工程指示 / 要求簡箋(E.I.)

工程指示編號：EI / 6741 / 23 修改版次：
 工程編號：J - 858 工程名稱：將軍澳日出康城
 工程項目：趟門梗中企 廠用鐵件 (特包屋)
 收件人：生統 / Maggie 發件人：Ant Yeung 日期：18/09/2023

內容：
按計數和 BD 批圖 3500 高的趟門中企 X86345 要 加力鐵 60x50 。

名稱	加力鐵加工圖	制圖	J.L.	2023-09-15	修改		
材料	60x50mm厚铁巴	復核			日期		
顏色	热浸锌	批准			圖號	J858-SD-GS06

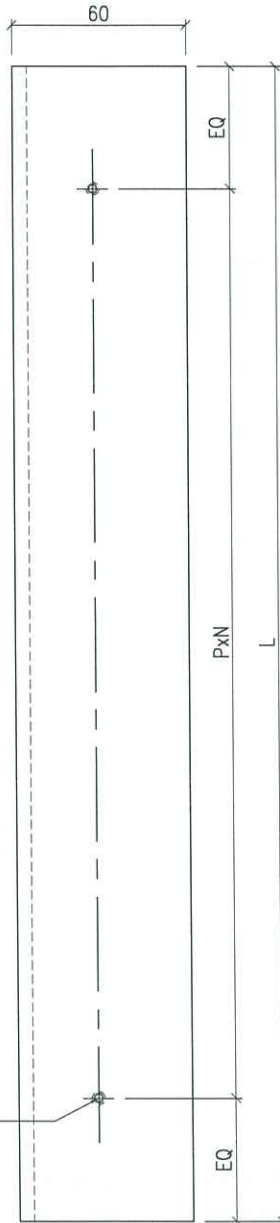
請生產送廠 特包屋趟門

附 BM 和 拆圖

加力鉸通

cut from
50mm plate

每幅門1只

工厂安装

8.1A Check Sliding Door Middle Mullion at penthouse

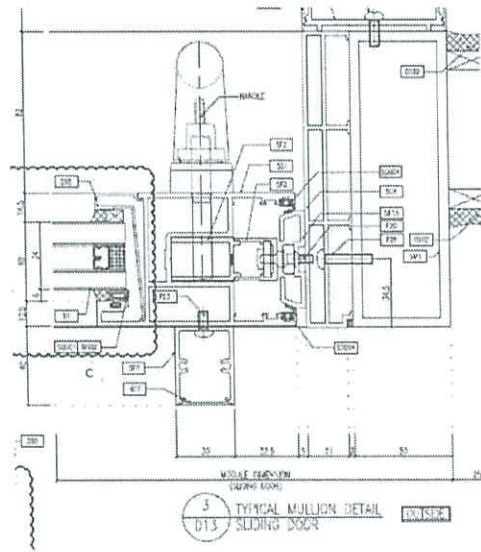
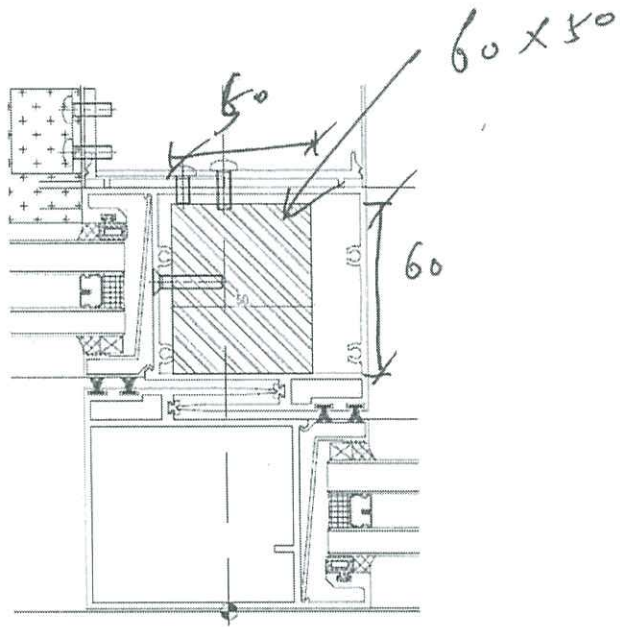
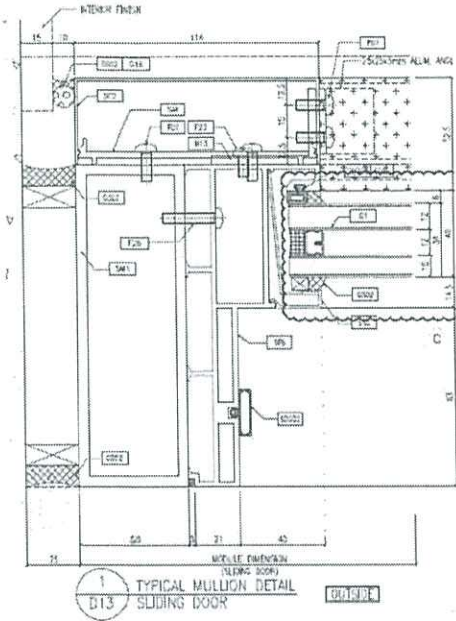
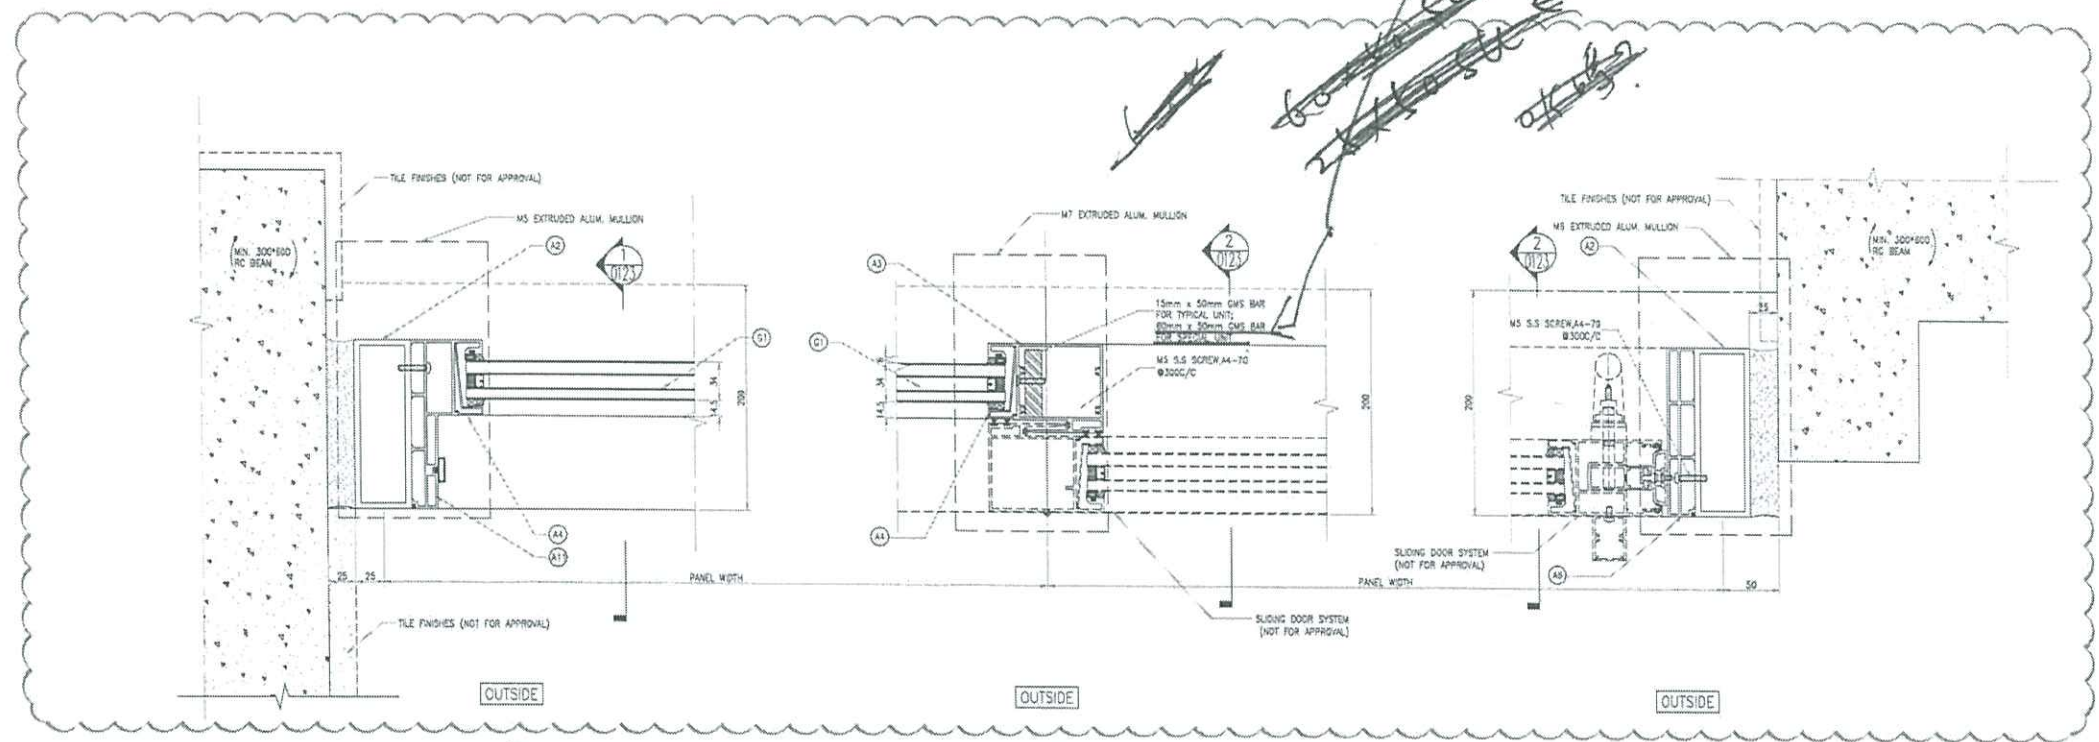
Refer to DWG: J858-CW-PE117

達 3500 高 超 門 的 加 力 鉗
